PD $I_{Port_RMS_max}$ requirement

Lennart Yseboodt, Matthias Wendt

Philips Lighting – Research

March 8, 2017

145.3.8.2 on Input average power says the following:

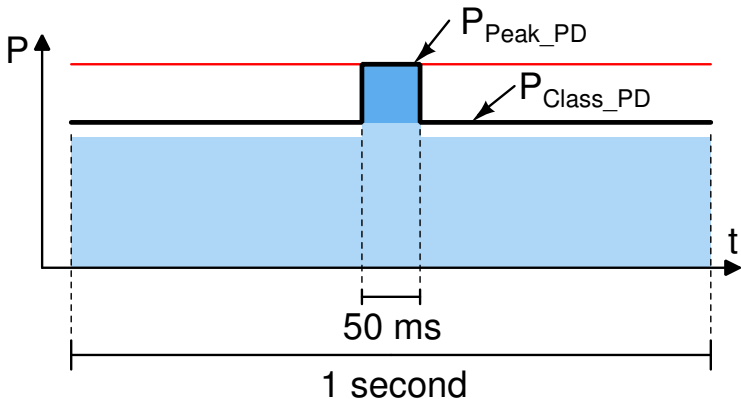
$P_{\text{Class_PD}}$ is the maximum average PI power and applies to single-signature PDs. The maximum average power, $P_{\text{Class_PD}}$ or $P_{\text{Class_PD-2P}}$ in Table 145-24, Table 145-25 and Table 145-28 or PDMaxPowerValue in 145.5.3.3, is calculated over a 1 second interval.

NOTE - Average power is calculated using any sliding window with a width of 1 s.

Average power is defined as the product of the RMS current and voltage.

- 1: Absolute max power consumption is P_{Peak_PD} .
- 2: Total blue area of a sliding window of 1 second must be $< P_{Class_PD}$
- 3: The $I_{Port_RMS_max}$ requirement is a repeat of (2) expressed in current.
